**IN RE THE GENERAL
ADJUDICATION OF ALL RIGHTS
TO USE WATER IN THE GILA
RIVER SYSTEM AND SOURCE**

Contested Case No. **W1-00-000106**

**REPORT OF THE SPECIAL MASTER
ON THE SUBFLOW ZONE
DELINEATION FOR THE VERDE
RIVER WATERSHED**

Figure 1 – Gap in lower Williamson Valley Wash (approx. river mile 2 to river mile 10)
ADWR extended the delineation for Williamson Valley Wash from river mile 10 to 30 (pink); did not explain the termination at river mile 2.

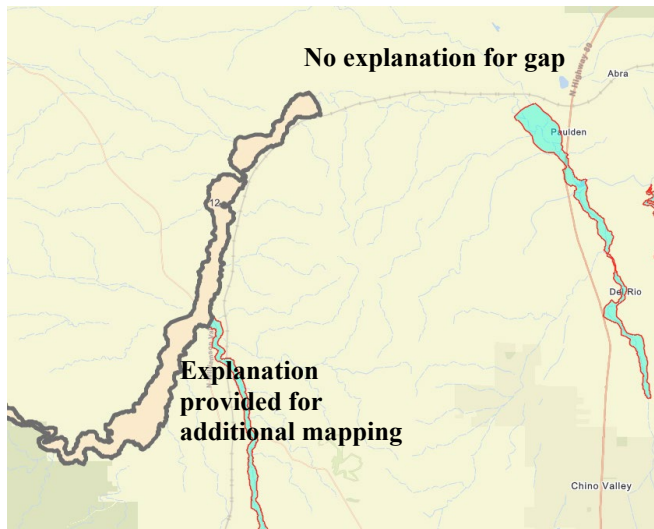
Williamson Valley Wash	11.5–16.5 on Brown; F&A; TNCAZ	0–2 and 17–18	+ 10–30	Additional subflow zone was mapped from river mile 10 to 30 where there was FHA and continuous riparian vegetation. No explanation provided for the gap in mapping from 2–10.

19
20 **IT IS ORDERED** that by **May 1, 2026**, ADWR shall file a supplemental report
21 explaining the mapping cutoffs illustrated in Figures 1–4.

Figure 2 – North Fork Sycamore Creek B (approx. river mile 5)
ADWR extended the proposed subflow zone for South Fork Sycamore Creek B (pink); did not explain the termination for North Fork.

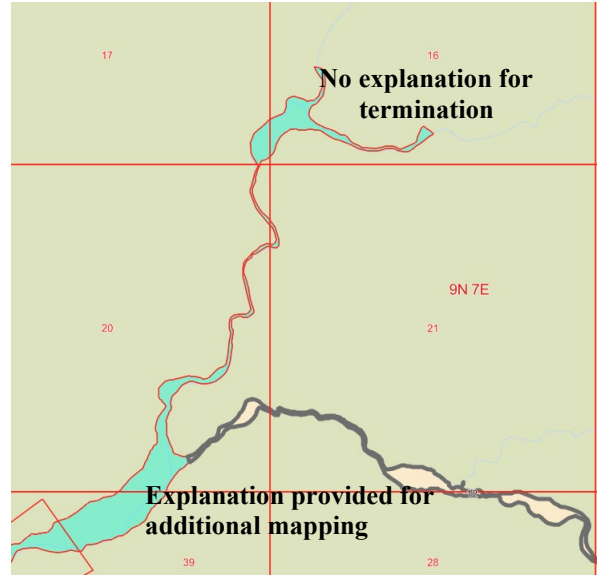
Sycamore Creek (B)	1.5–6 on Brown; F&A; TNCAZ	0–5	+5–6	Extended the proposed delineation from a southern fork to Sycamore Creek B located at approximately river mile 3.5 to where the perennial stream classification ends. ADWR did not explain the terminations at approximately river mile 5 of the northern fork.
Sycamore Creek (C)	10–34 on Brown; F&A; TNCAZ	0–34	None	No objections - geology changed to bedrock with no additional mappable alluvium beyond the stopping point.

Figure 4 - Tributary to Clover Creek (approx. river mile 2.5)
ADWR extended delineation for Clover Creek (pink); did not explain termination for the pictured tributary to Clover Creek.

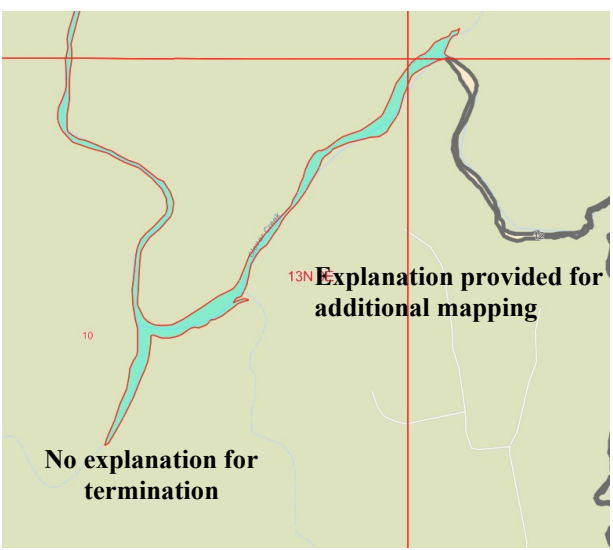
Tributary Name	Source for Streamflow Categorization ^A (river miles ^B)	AZGS Geologic Mapping (river miles)		2025 Addendum Subflow Delineation
		2022 Tributaries Report	2025 Addendum	
Adler Creek	2.2–5 on Brown; F&A	0–8.5	None	No change – geology changed to bedrock with no additional mappable alluvium.
Apache Creek	2–3 and 5–6 on Brown	0–5.5	None	No change – geology changed to bedrock with no additional mappable alluvium.
Camp Creek	14–18 on Brown; F&A	12–18.5	None	No change – no additional mappable alluvium beyond the stopping point and the perennial stream classification did not continue beyond the stopping point.
Clover Creek	0–7.5 on Brown; F&A; TNCAZ	0–3.5	+ 3.5–7	Extended the proposed subflow zone to approximately river mile 7 where the perennial stream classification ends. ADWR did not explain the termination at the southern tributary to Clover Creek.
